Memo

To: Casey Durden
From: Gilbert Combs, Associate Planner; 910-341-4661
CC: File;
Date: 9/16/2019
Re: Chick-fil-A Rev 2

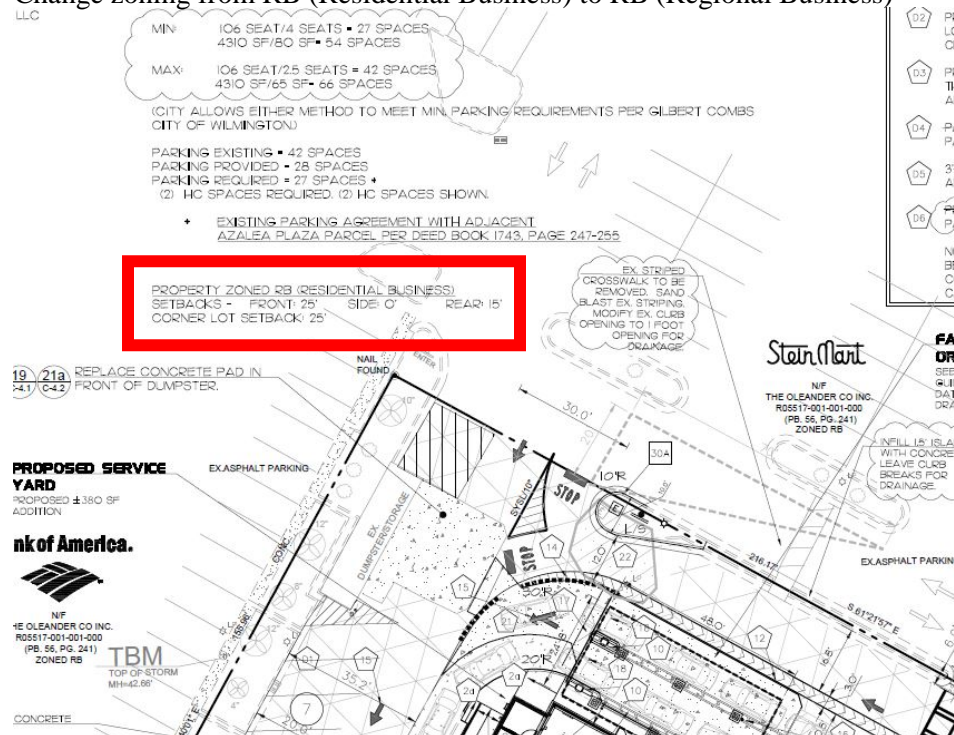
- The strip of landscaping between the subject site and the Stein Mart drive aisle needs a minimum of one (1) tree every eighteen (18) to twenty-seven (27) feet. [Sec. 18-482]
 - Adding a tree to the western end of this landscaped strip would satisfy this requirement.

NOTE:
EXISTING 6" ELM SHALL BE REMOVE
REPLANTED WITH A 2.5" CALIPER EL
